Access Compliance Report Public Rights-of-Way (RR Crossings)

Intersection ID: 10034711	Main Street: POINDEXTER_DR	Location:	N/A
ADA ID: 43CCBF43326E	Overall Compliance: No	Severity Score:	0.0
Codes/Mitigation Info/Possible Solution		Field Measurements/Component Compliance

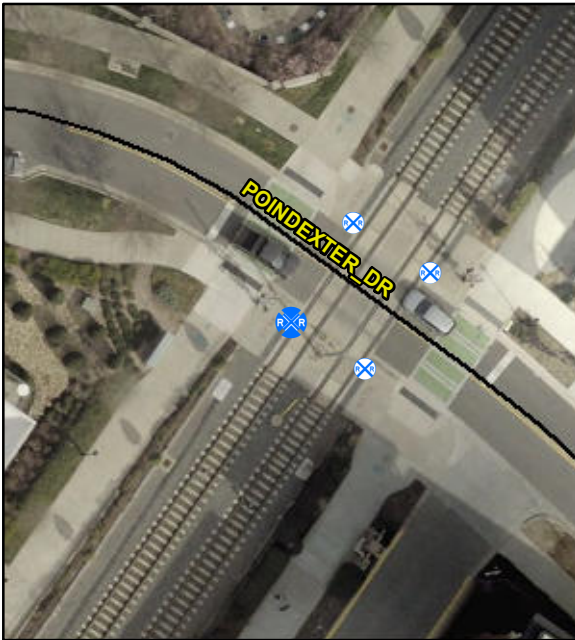
Remove & Replace Detectable Warning System. Provide Pedestrian Gate. Remove & Replace Walking Surface Adjacent to Rail.

R302.7.4, R305.2.5

Compliance	Description	Data
Yes	DWS Provided?	Yes
Yes	DWS Contrast?	Yes
Yes	DWS Width (in)	Yes
Yes	DWS Length (in)	24.0
No	DWS Offset (in)	12.0
No	Pedestrian Gate?	No
N/A	DWS Outside Gate?	N/A
N/A	Rail Type?	LightRail
No	Flangeway Gap (in)	3.0
Yes	Sidewalk Width (in)	92.0
